**SYDNEY WESTERN CITY PLANNING PANEL
SUPPLEMENTARY COUNCIL ASSESSMENT REPORT
Superlot subdivision / subdivision Austral West**

SSWPP No	PPSSWC-210
DA Number	DA-1295/2021
Local Government Area	Liverpool City Council
Proposed Development	<p>Superlot and residential subdivision over 3 stages – including site remediation, dam dewatering, vegetation clearing, subdivision of existing allotment into a torrens title staged subdivision of 123 residential lots and 22 residue lots and construction of roads and associated civil works.</p> <p>Stage 1: Subdivision of one existing allotment (Lot 184 DP1237400) to create 9 superlots for future development (superlots 101 to 109).</p> <p>Stage 2: Subdivision of proposed superlot 101 (Austral West) created under Stage 1 to create 60 torrens title residential lots (Lots 1 to 36, 39 to 42, 44, 45, 47 and 52 to 68) and 11 residue lots (Lots 37, 38, 43, 46, 48 to 51, 69 and 70).</p> <p>Stage 3: Subdivision of proposed superlot 70 (Austral West) created under Stage 2 to create 63 Torrens title residential lots (Lots 201 to 217, 219 to 230 and 232 to 265) and 4 residue lots (Lots 218, 231, 266 and 267).</p>

Recommendation	Approval (Deferred Commencement)

Figure 2: Intersection configuration Road 02 and 16

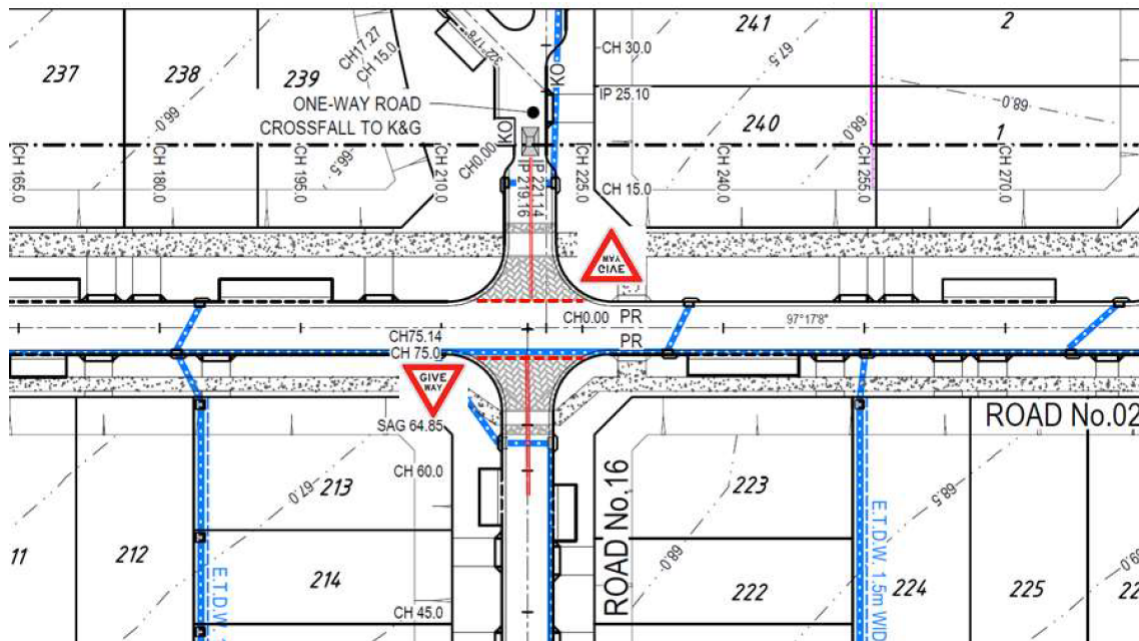
Landcom supports and can deliver the requested roundabout at the intersection of Roads 01 and 13, but not at Road 02 and 16.

In subsequent correspondence, Council has agreed that a roundabout at Road 02 and 16 is not required but has requested that adequate provision of landscaping should be provided to enable the implementation of a roundabout at a later stage, if/when required. Council notes this may require the applicant to undertake the design of a roundabout, to indicate the impact on adjoining land parcels.

Landcom does not agree to the requirement for provision for a roundabout in the future. Landcom's traffic and transport consultant has provided the following information in this regard (Attachment D):

- *This intersection (Road 02 / Road 16) was not identified in the Addendum Post-Exhibition Traffic Report (AECOM) that it needs to be upgraded to a roundabout or traffic signals.*

- *This intersection was not identified in the Liverpool Contributions Plan 2014 Austral and Leppington North Precincts that it needs to be upgraded to a roundabout or traffic signals.*

- *This intersection is at the junction of a local street and a shared street hence with relatively low volumes of local traffic, hence would not trigger the need for a roundabout or traffic signals.*

- *Since Road 16 and Road 06 are local streets and not meant to carry through traffic and operate as collector streets, the amount of traffic that would be expected to be turning into and out of Road 06 and Road 16 onto Road 02 is limited to those generated by the dwellings on Road 06 and Road 16. Hence the other reason that a roundabout is not warranted to manage the turning traffic at this intersection.*

- *Road 16 also does not extend further south of Lapwing Street hence does not draw any additional traffic from the rest of the precinct and therefore is expected to have very low traffic volume.*

- *Hence it would just be configured as a conventional give-way intersection, with give-way signs and linemarking on the northern and southern approaches of Road 06 and Road 16 respectively, as shown in sketch below.*

Landcom's proposed intersection configuration of the intersection of Road 02 and 16 is shown at Figure 2 below.

The proposed treatment of intersection of Road 02 and 16 is considered appropriate based on the traffic advice provided by Landcom.

The requested condition has been updated to remove the requirement to provide a roundabout at the intersection of Road 02 and 16 (Condition 59).

Figure 3: On-street car space locations

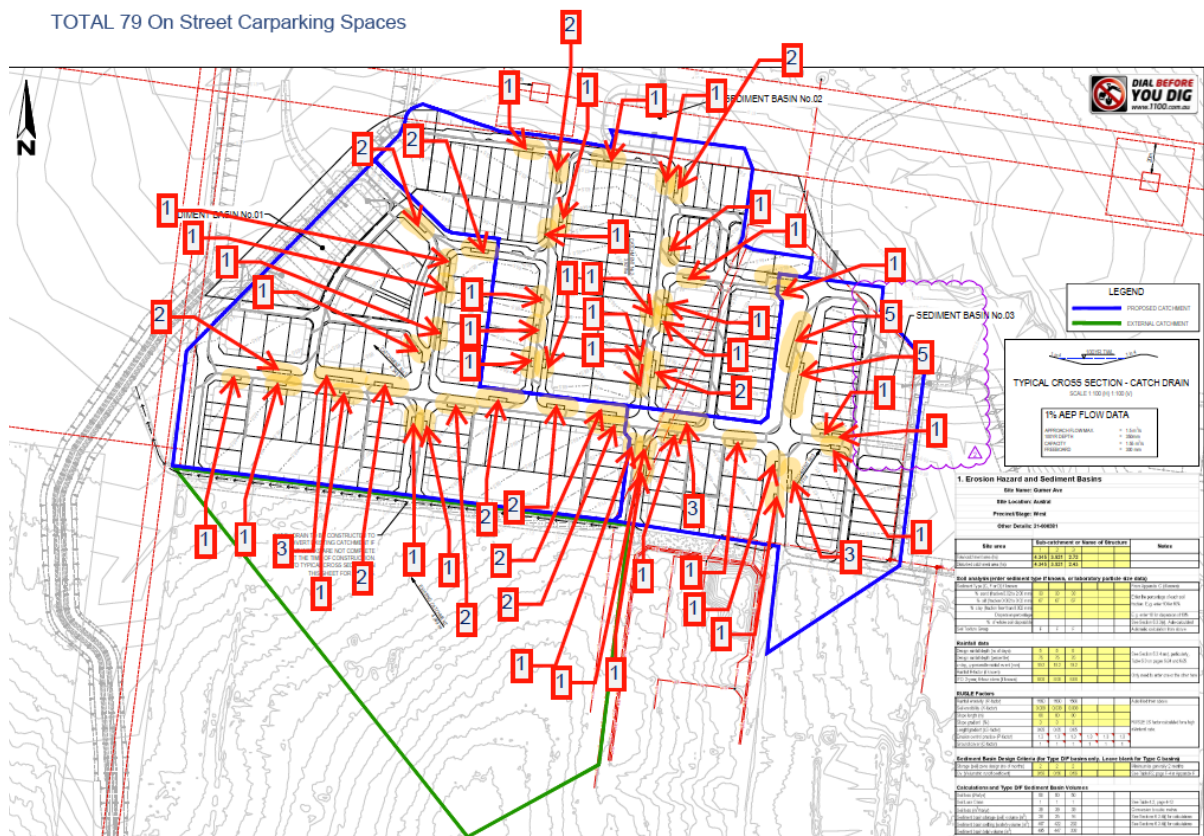
The traffic and transport referral has requested a condition requiring the applicant to demonstrate that the detailed design of the road network provides adequate on-street parking.

Landcom does not support this condition on the basis that 'adequate' is not defined and there is no DCP control which would define this.

Council subsequently advised the following:

Adequate refers to compliant in regards to AS2890 parking lengths. It also refers to placement of spaces to maximise parking opportunities without impacting sight visibility or access arrangements. Essentially the condition relates to providing as much parking provision as possible within the proposed road reserves, including within the currently proposed verges.

Landcom has provided an excerpt of the Civil Plans which show locations and number of parking spaces totalling 79 (see Figure 3).

The condition recommended by Council does not quantify the required car parking spaces and a standard does not exist for the required amount of on street parking. As such the proposed condition doesn't provide the certainty required for a legal condition. It is recommended that this condition not be included in the approval, and that car parking is approved as per the civil plans.

Accordingly, the condition is not recommended to be required.

Figure 4: Location of Edmondson Avenue / Gurner Avenue intersection

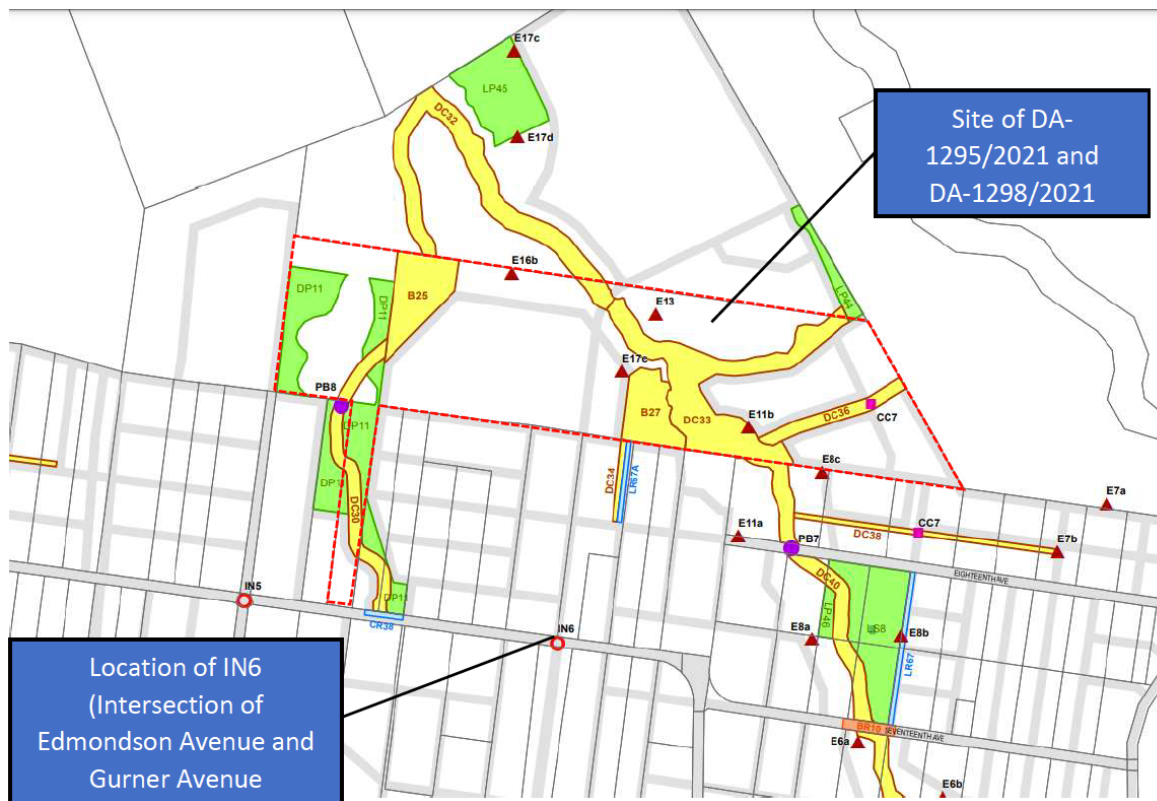
The traffic and transport referral notes that the intersection of Gurner Avenue and Edmondson Avenue which provides the connection to the external road network needs upgrading to safely accommodate the traffic to be generated by the proposed Landcom development as well as the Crownlands development (see Figure 4).

Council subsequently advised that it agrees that the works would be constructed by Council as part of the S7.11 contributions plan and raises no objection to a works in kind agreement, and requested the following condition in this regard:

The roundabout at the intersection of Gurner Avenue and Edmondson Avenue, identified in the S7.11 Contributions Plan, is preferred to be delivered by Landcom prior to issue of the SWC.

Council will contribute a maximum of \$242,935.00 (The current budget allocated in the S7.11 Scheme) so that landcom can undertake the works on Council's Behalf. The developer will be required to enter into a 'Works in Kind' agreement with Council's S.7.11 Contributions Team prior to the works proceeding.

All Detailed Design Drawings and Signage and Line marking plans will need to be amended to reflect the inclusion of the RAB and must be approved by the relevant sections in Council, prior to works commencing.

Landcom has sought clarification of the condition to make it clear that Landcom retains discretion as to whether it enters into a works in kind agreement to deliver the intersection upgrade. Landcom notes that Council may require additional road acquisition by Council that Landcom will be not be party to, nor can the development be held up for this. Landcom further notes that the roundabout does not form part of the works in the DA and would need separate approval.

This change is considered to align with Council's position and the condition has been amended to clarify that Landcom may enter into a works in kind agreement (Condition 59).

This matter is considered to be satisfactorily addressed.

Figure 5: Northern extension to Edmondson Avenue

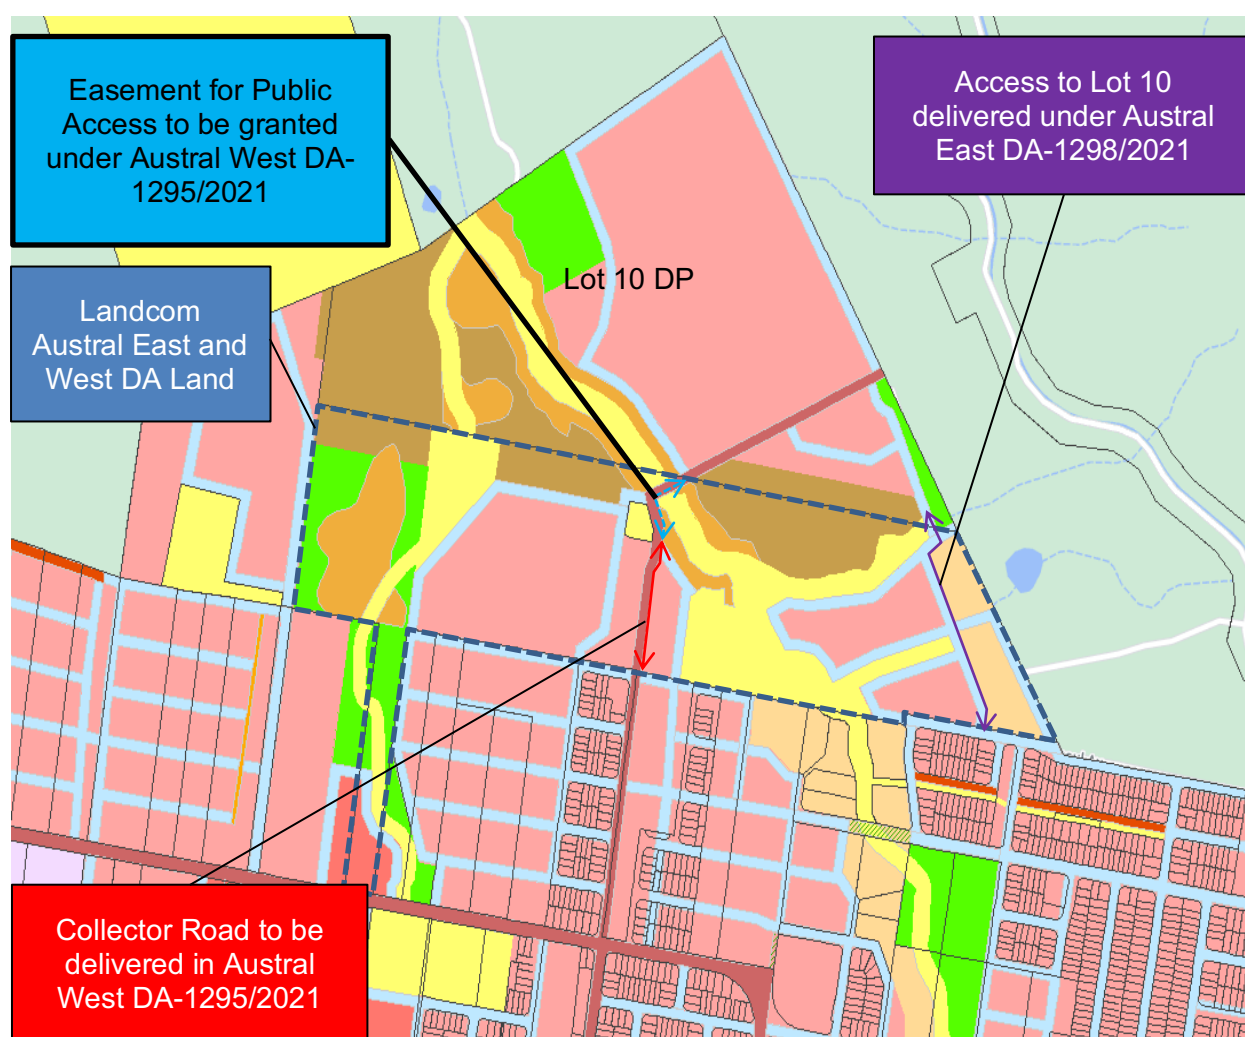
The traffic and transport referral requests a condition requiring the development to include the construction of the northern road (northern extension of Edmondson Avenue through the Landcom site) leading into Lot 10 Gurner Avenue, Austral up to the property boundary as shown in the Indicative Layout Plan (see Figure 5).

Landcom do not accept the condition and considers there is no nexus to the development to deliver this length of road as it serves no purpose to the proposed subdivision.

Landcom agrees to a requirement to register an easement for public access that will allow the developer to the north to complete the road as and when is required. Office of Strategic Lands can also agree to provide Council with an MOU that states they have no objection either to transfer the area of the easement to the adjoining landowner (if required) or alternatively provide owners consent for the construction of the road over this part of the land and its future dedication.

To provide for orderly development of the precinct, and ensure that identified road reservations within the Indicative Layout Plan are delivered by the relevant landowner, it is recommended Landcom be required construct the northern extension of Edmondson Avenue to the property boundary as shown in the indicative layout plan.

The extension of this road does not form part of this development application and would need to separately approved.

The following conditions have been included in the recommended approval to require this section of road to be delivered alongside the development subject of this application (Condition 154 and 155).

- Prior to issue of the Subdivision Certificate for Stage 2 approval is to be obtained for construction of the extension of Road No. 1 (Edmondson Avenue) to provide collector road access to the adjoining property boundary.
- Prior to issue of the Subdivision Certificate for Stage 3 construction of the extension of Road No. 1 (Edmondson Avenue) to provide collector road access to the adjoining property boundary is to be completed.
